From: [Yu, Olivia, EMNRD](#)
To: [Andrew Parker](#)
Cc: [Billings, Bradford, EMNRD](#); [Hernandez, Christina, EMNRD](#); "[Bradley Blevins](#)"; "[David Harwell](#)"; "[Jimmy Smith](#)"; "[Clabe Pearson](#)"; r@rthicksconsult.com; [Christopher Cortez](#)
Subject: RE: Advance Energy - 1RP-4953
Date: Monday, July 30, 2018 5:22:00 PM

To: David Harwell (Advanced Energy)
From: Andrew Parker
CC: Ms. Yu (NMOCD)
Date: July 27, 2018
Re: 1RP-4953 – Produced Water Releases; 1RP-4778 Tomahawk SWD;
1RP-4821 – Coop 6 State Com Battery (1H)

Battle 34 & East of Battle 34 [1RP-4953]

Figure M 11: Photograph of SP-26 viewing east toward the COOP 6 State 1H location. The release is within a small undefined drainage. The surround area supports vegetation.

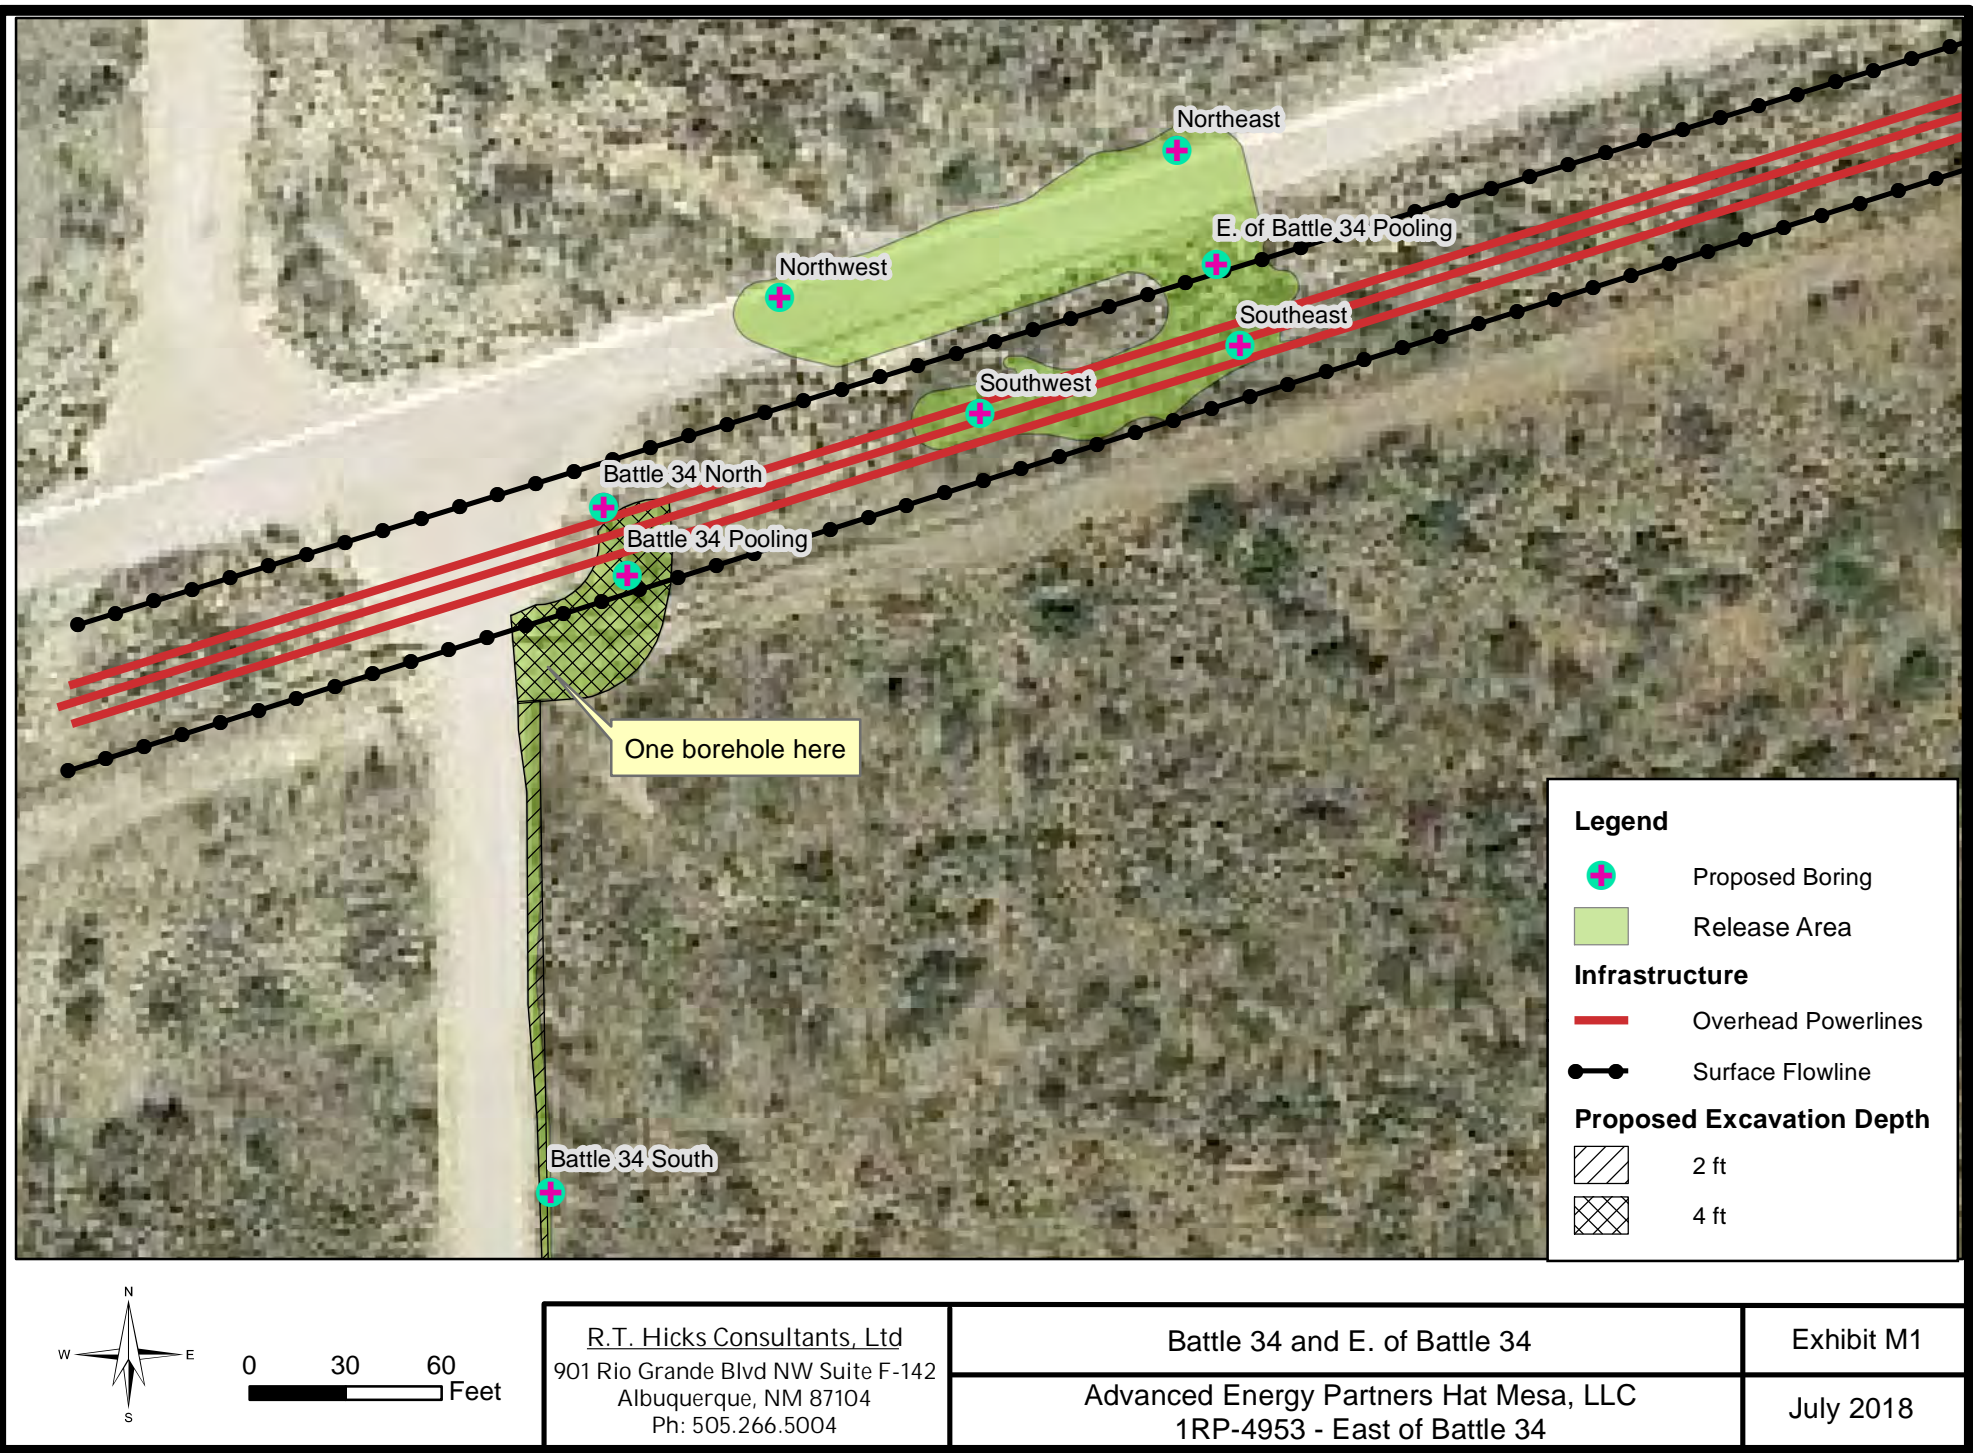
Exhibit M6 shows the location relative to the release extent and nearby infrastructure. As shown in Exhibit M6, three locations are identified for vertical delineation. All three locations are not suitable for drilling. Borehole SP-16 is located near a buried pipeline (Figure M10). Moving the location to the north will place the borehole out of the release area. Location 21 & 26 lies within an area that has vegetation growth. Accessing these two areas with a drill rig will cause unnecessary damage to the vegetation (Figures M11 and M12). Location 21 exhibits evidence of the release as indicated by hydrocarbon staining (Figure M13). We recommend restoring the upper soil layer in this area.
